# A d d e n d u m

Iowa Department of Transportation  
Office of Contracts

<b>B.O.</b>	<b>Proposal ID</b>	<b>Proposal Work Type</b>	<b>County</b>	<b>Project Number</b>	<b>Addendum</b>
011	77-0354-140	BRIDGE REPLACEMENT - PPCB	POLK	IM-NHS-035-4(140)92--03-77 IM-NHS-035-4(193)93--03-77 IM-NHS-035-4(194)94--03-77 IM-NHS-035-4(218)93--03-77 NHS-035-4(221)93--11-77	18JUL011A02

Make the following changes to the PLAN for Project # IM-NHS-035-4(194)94--03-77:

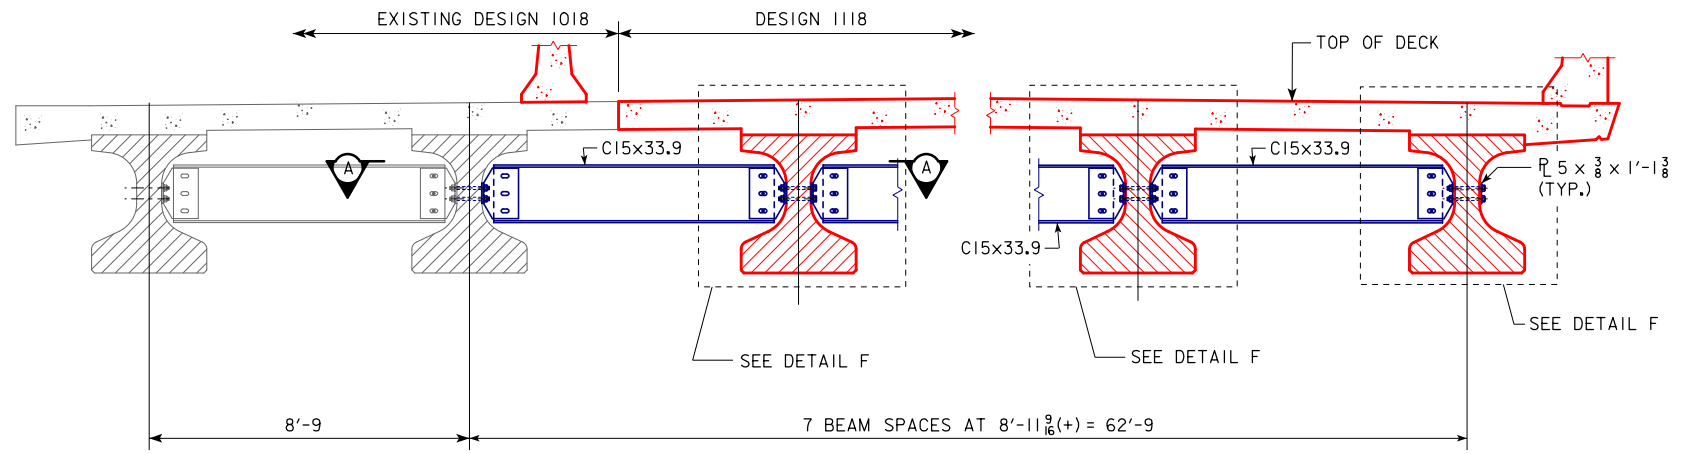
Note: SHEET 33 - Removed Note regarding "Removals as per plan."

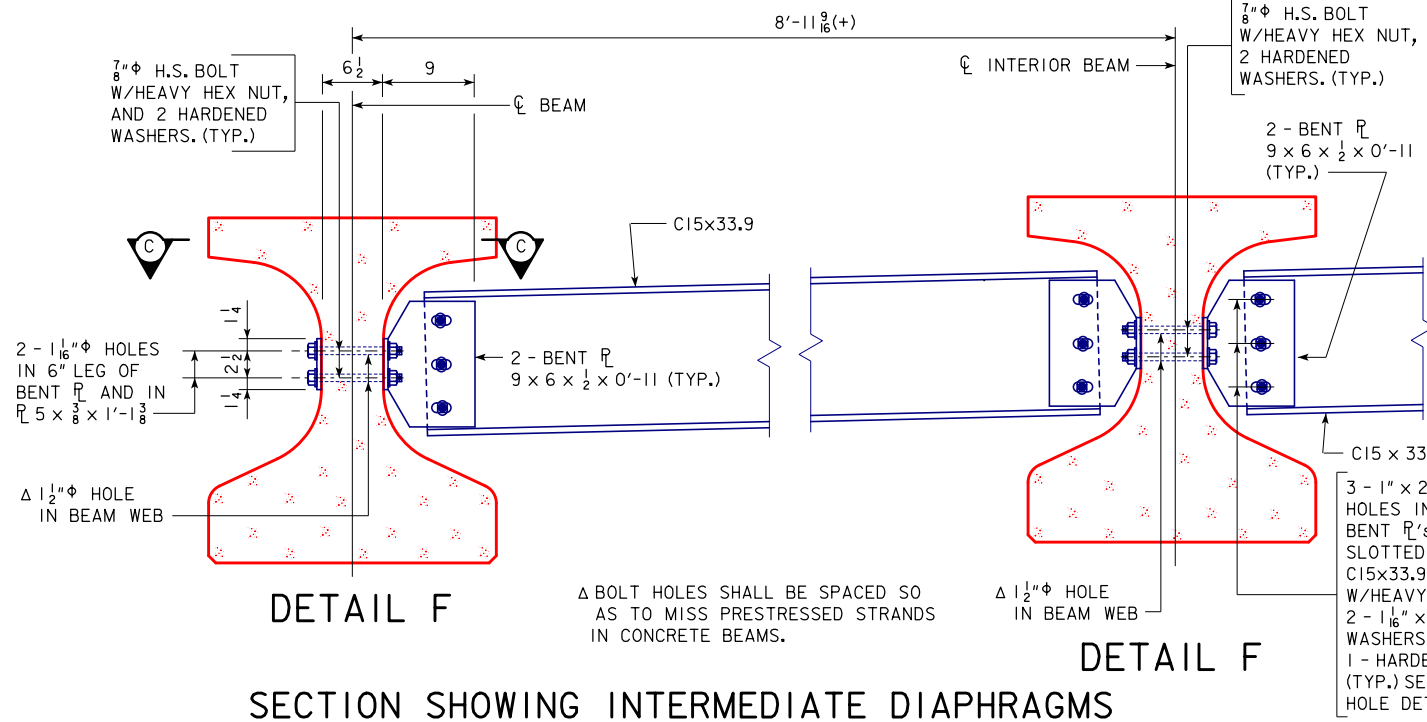
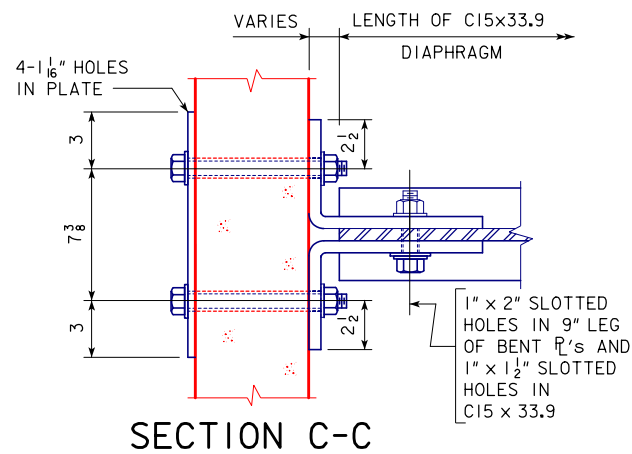
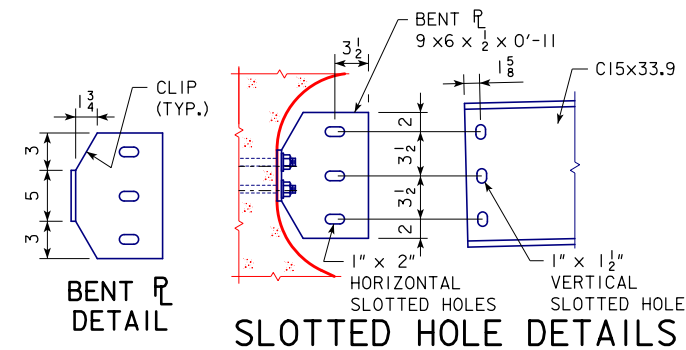
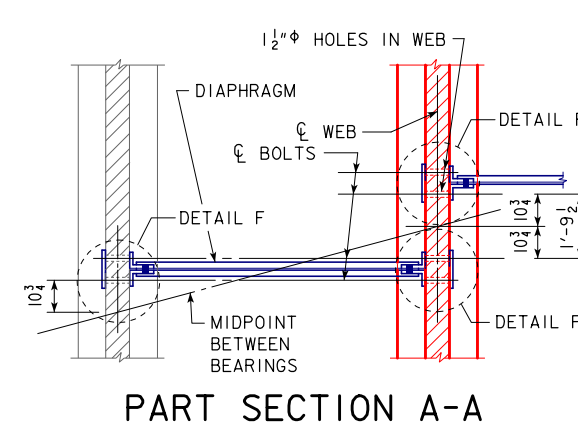
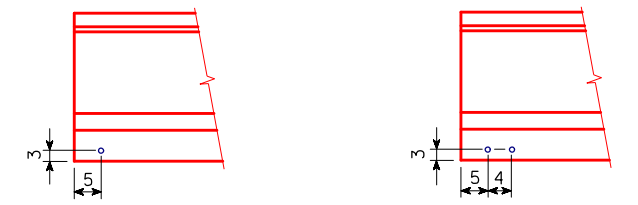
SHEET 60 - Update to the diaphragm spacing and quantities.
